VALUE ENGINEERING SUMMARY OF US 119/ZEBULON TO BENT MT. WPI NO. 12-308.1 & 308.2 PIKE COUNTY, KENTUCKY

Prepared by: Ventry Engineering

Kentucky Transportation Cabinet, Department of Highways

MEDIAN WIDTH

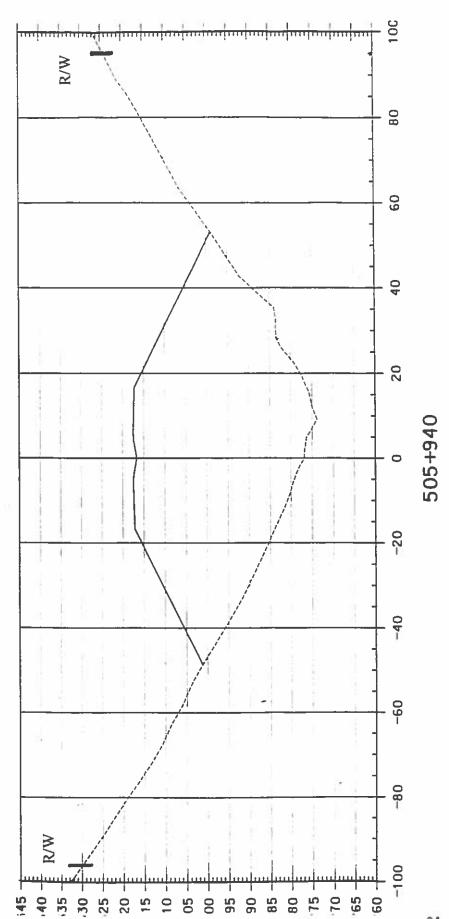
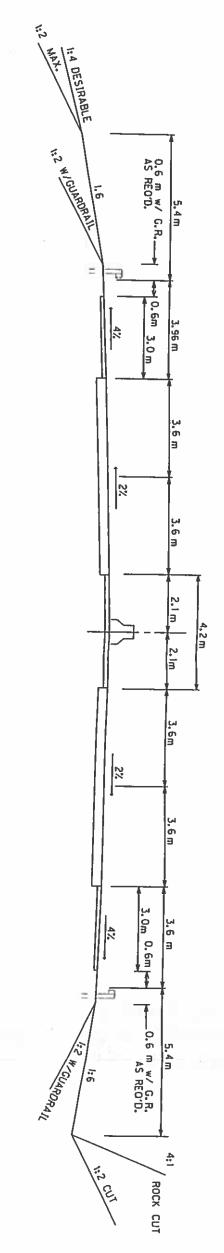
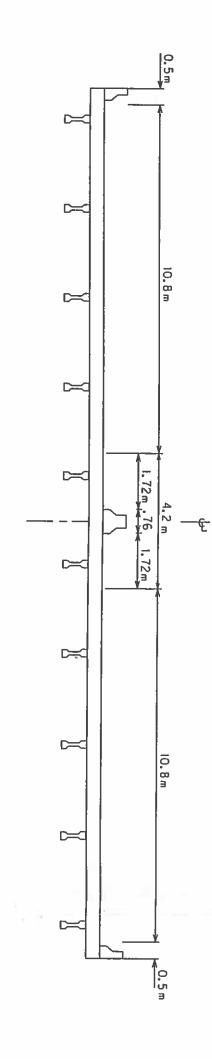
The as proposed typical section incorporates four lanes at 3.6m, two median shoulders of 1.2m paved and .6m unpaved, two exterior shoulders at 3.0m paved and .6m unpaved. The median is a 12m depressed median. This section provides for drainage of both roadways and provides for snow storage, left turns and storage lanes.

The V.E. alternative typical section incorporates four lanes at 3.6m, two exterior shoulders at 3.0m paved and .6m unpaved. The median is 4.2m wide with a traffic barrier in the middle of the median. The barrier will be used throughout except where approach roads will have a left turn movement (Winn Branch only).

This typical provides for drainage, left turns and storage lanes.

FILL SLOPES

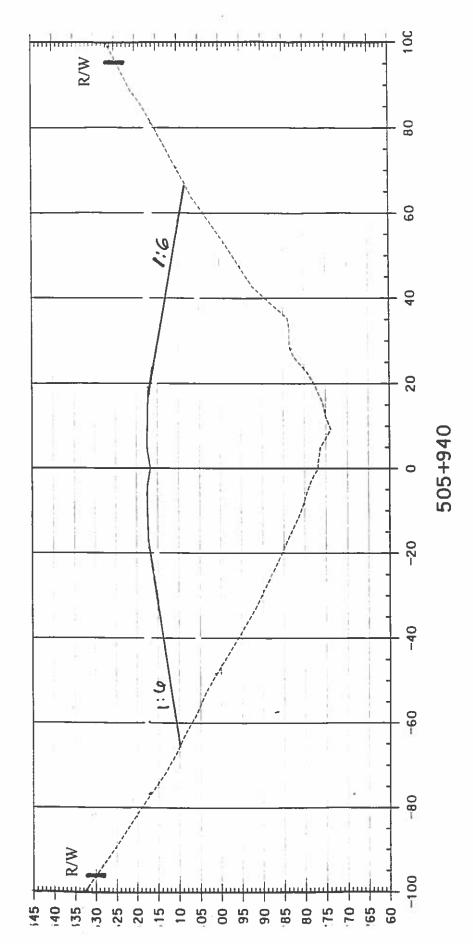
The V.E. team recommends a typical section to provide modified slopes that will allow for the utilization of additional excavated material from station 504 + 800 to station 505 + 260, station

505 + 460 to station 506 + 200 and station 508 + 640 to station 509 + 060. This will reduce the amount of waste, the waste area required, and guardrail necessary.

helt End suardrail eliminated by waste usage or flattening slopes

Right side quardrail eveninated

ALIGNMENT

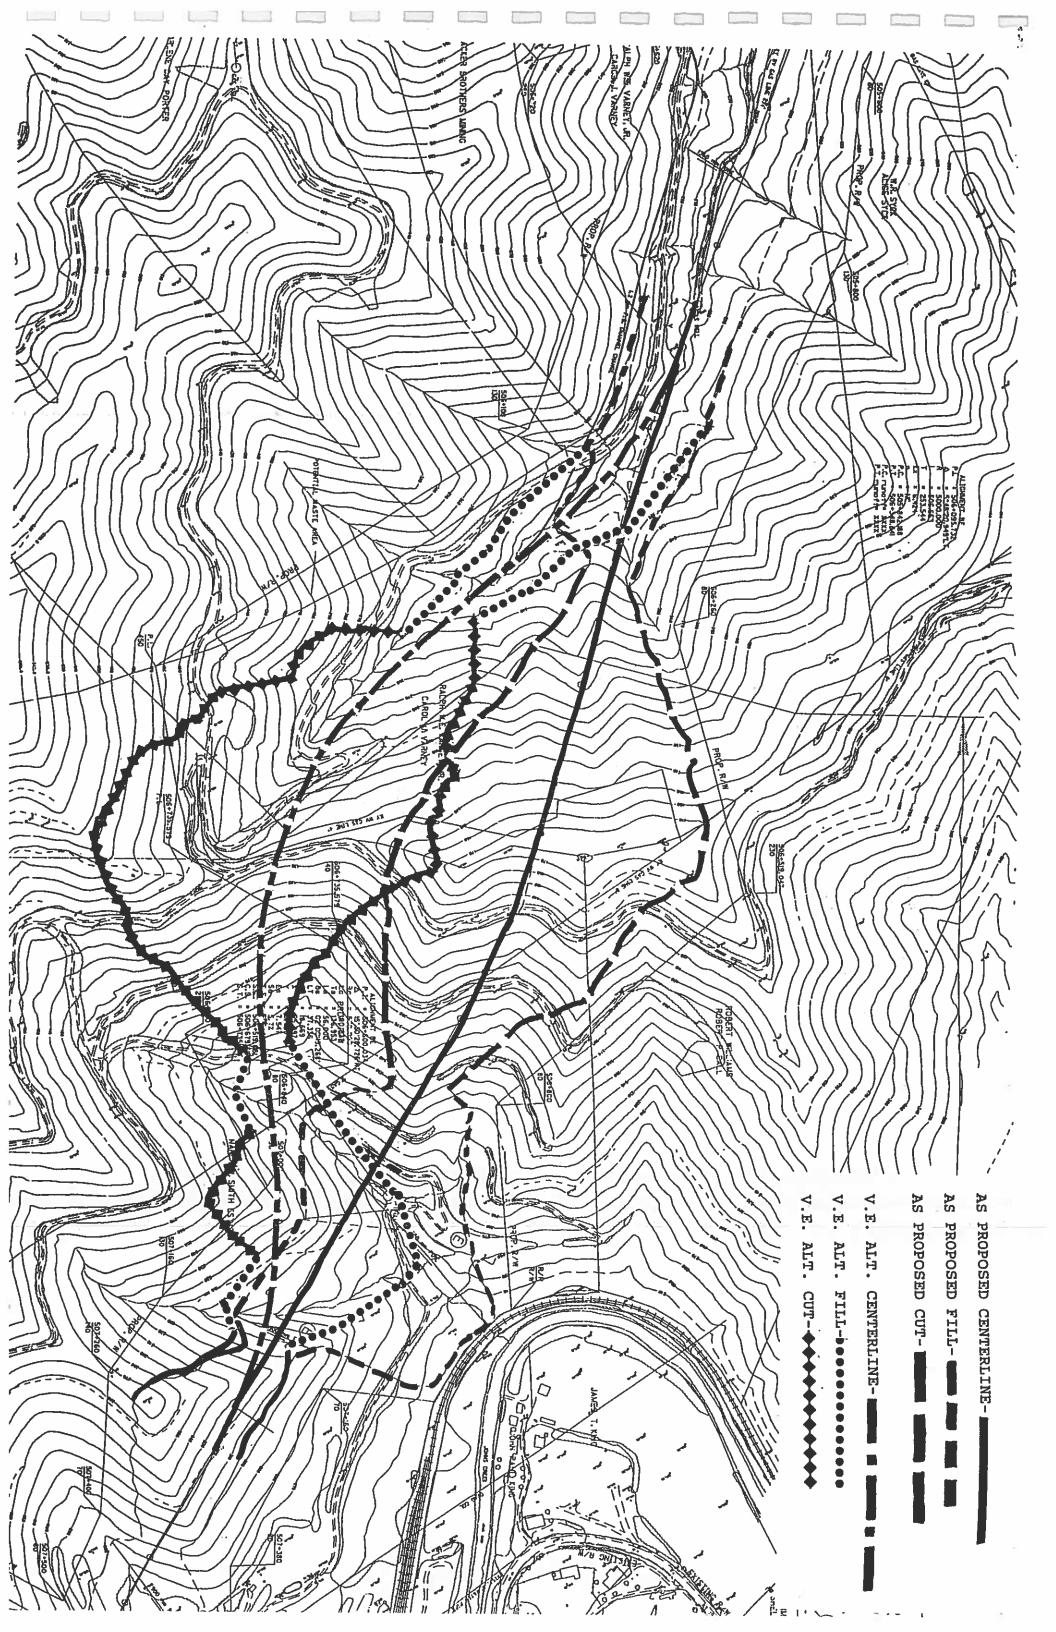
The V.E. team recommends that the alignment be relocated through the saddle located southerly of the proposed alignment. This greatly reduces excavation and the volume of waste.

BRIDGE TYPICAL (EXTERIOR SHOULDER 3.6 VS. 3.0)

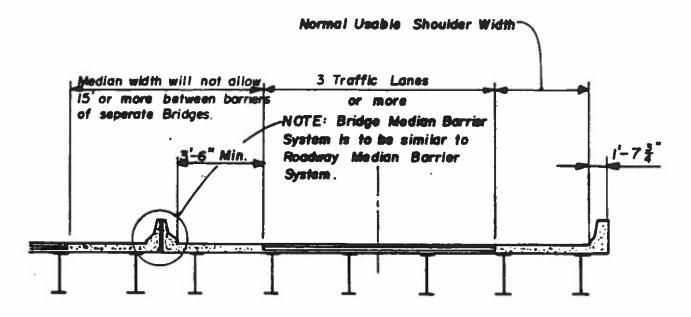
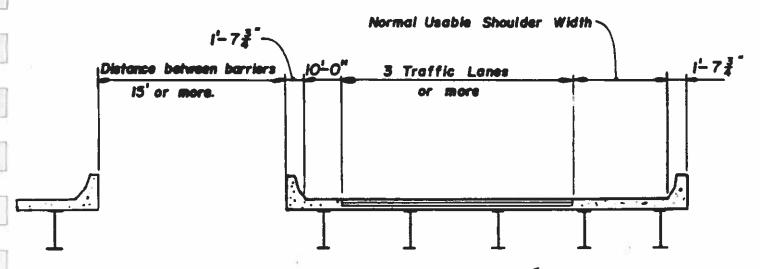
The As Proposed Typical for the bridges incorporates 3.6m exterior shoulders, two 3.6m lanes, a 1.8m interior shoulder and two barriers at .5m each. This typical is for each bridge. The 3.6m exterior shoulder could encourage people to use this as a travel lane. (See AASHTO Geometric Design Chap. IV, Pg. 338).

The V.E. Alternative incorporates 3.0m exterior shoulders, two 3.6m lanes, a 1.8m interior shoulder and two barriers at .5m each. This typical reduces each bridge by .6m each. A 3.0m shoulder is adequate for emergency use and is consistent with the typical section for the adjacent Bent Mountain project and with the Basic Geometric Design Standards (Exhibit 66-03-06).

BURNING FORK

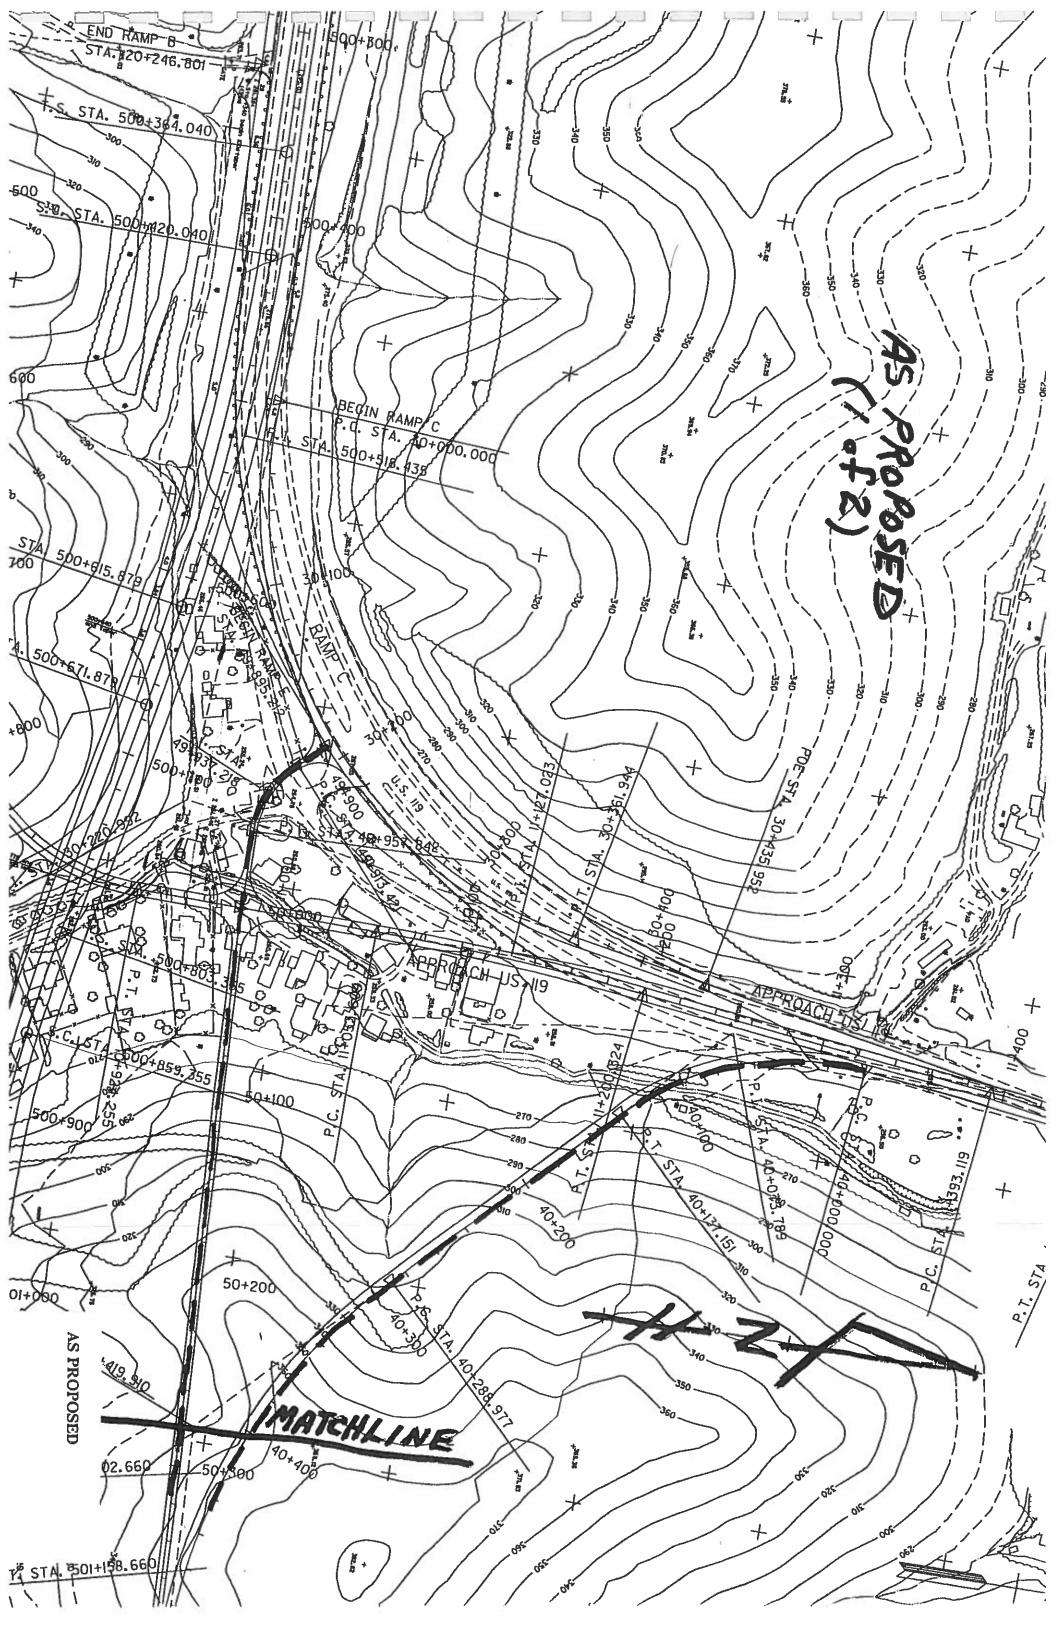
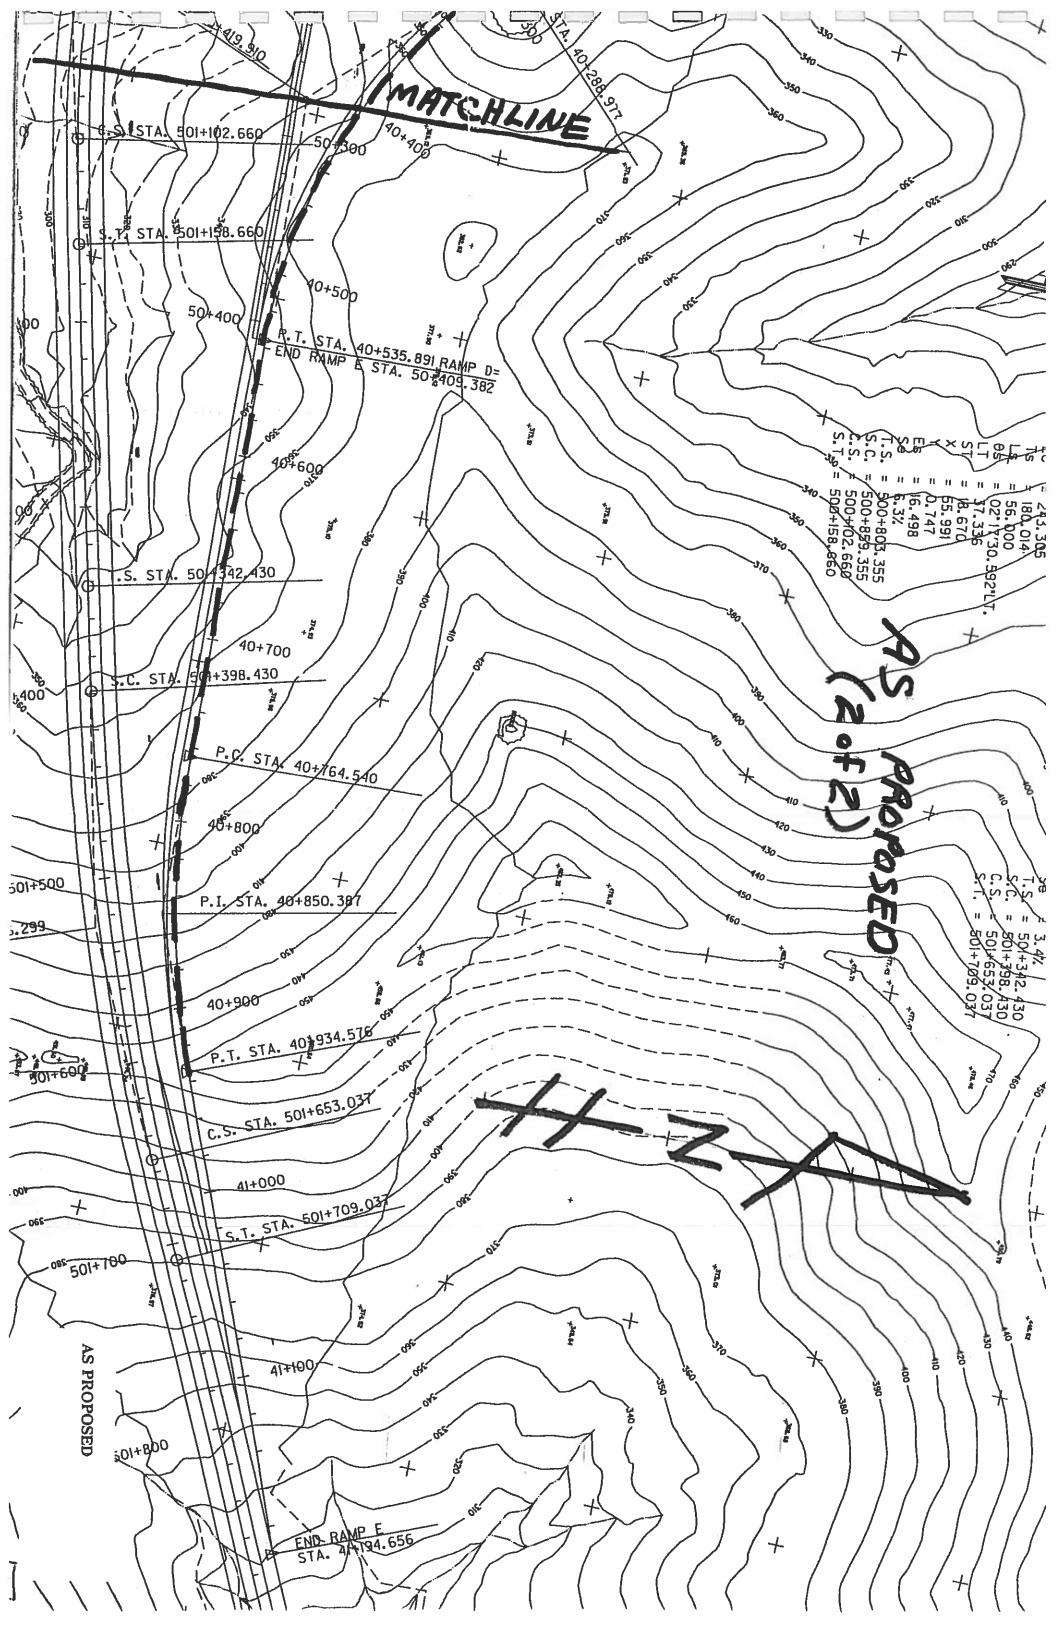
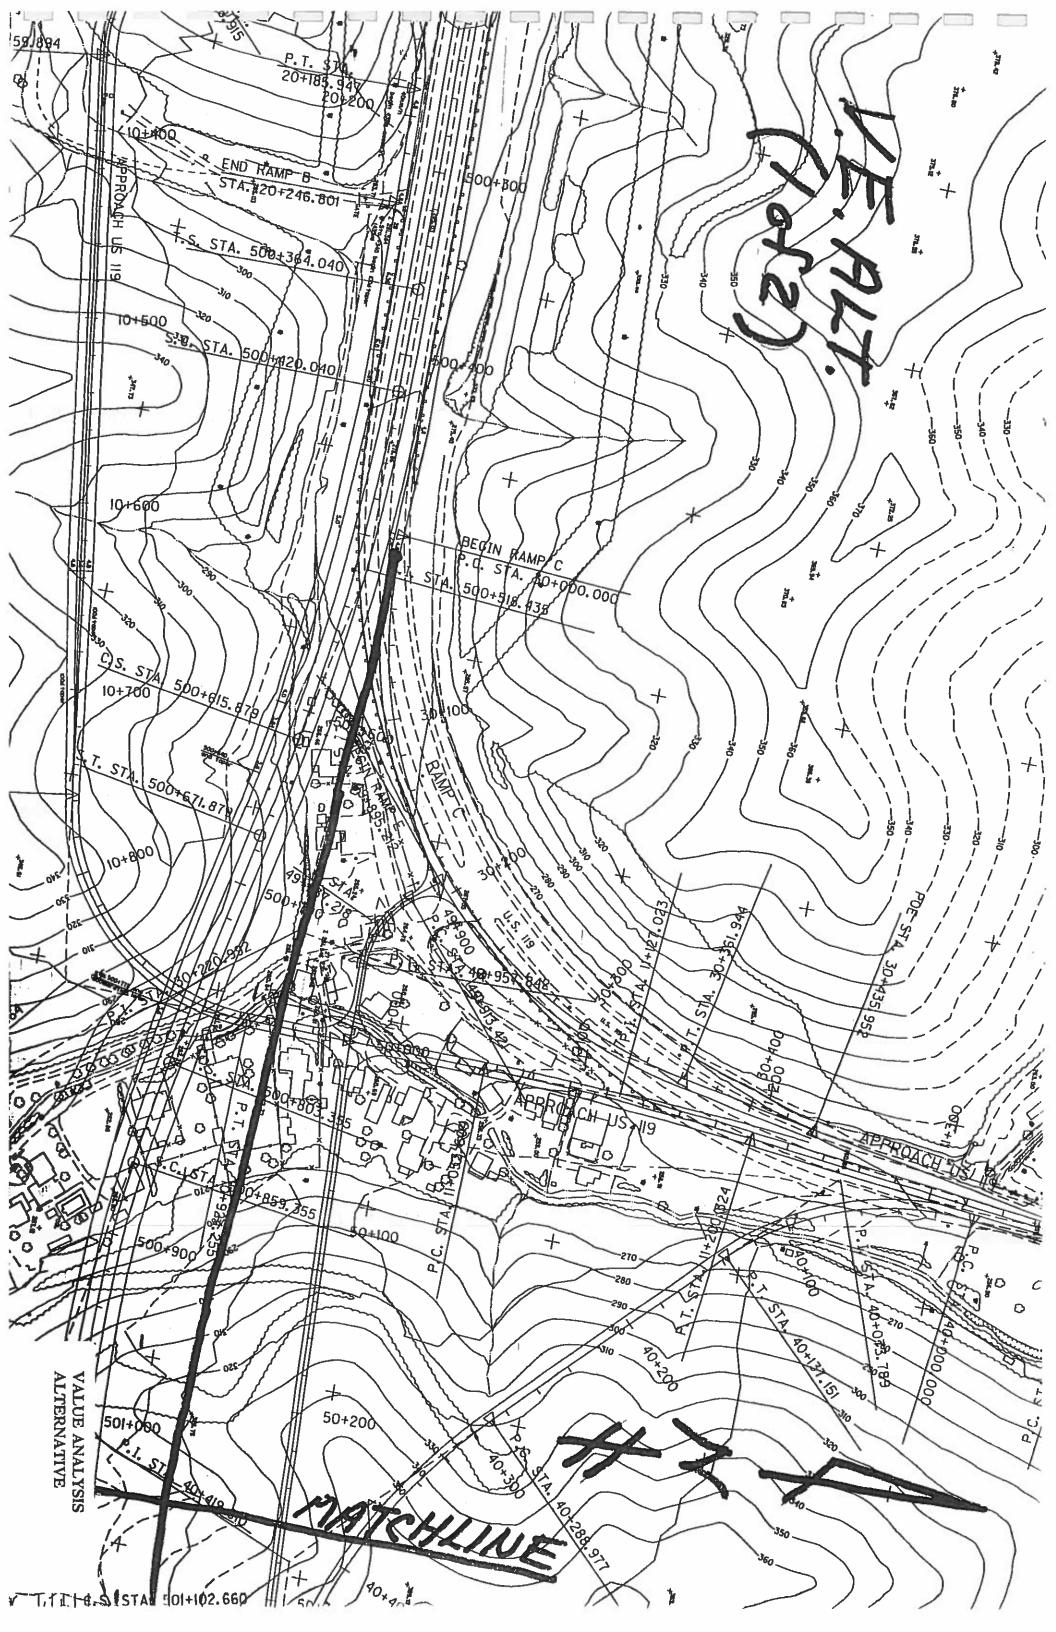
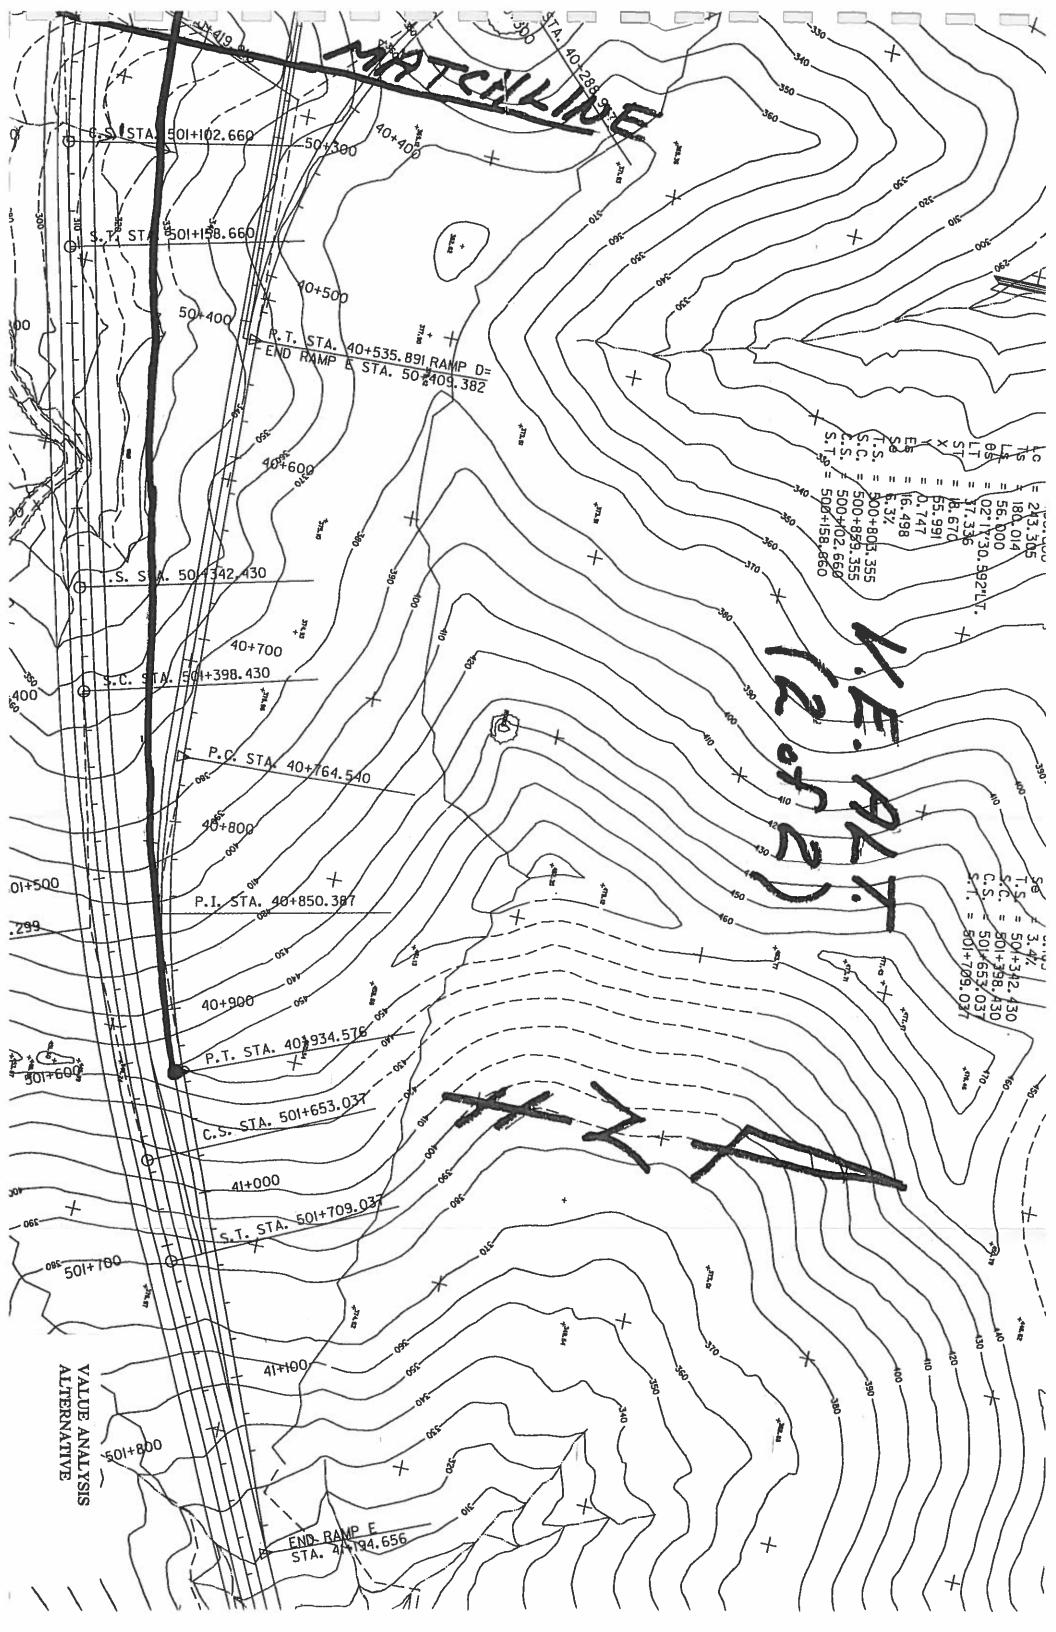
The proposed plan provides an off ramp (ramp D) from West to North for old U.S. 119. There is also a West to West ramp (ramp E) for Burning Fork Road South.

The V.E. team recommends that Ramp D be eliminated from station 40 + 000 to 40 + 535. Ramp E will be moved southerly toward the mainline and will intersect Ramp C at a more westerly location and closely (southerly) toward the mainline. Access north and south to old U.S. 119 (Burning Fork Road) is provided for west bound traffic along Ramp E. This eliminates more than 400M of ramp through a cut, reduces right of way requirements and waste.
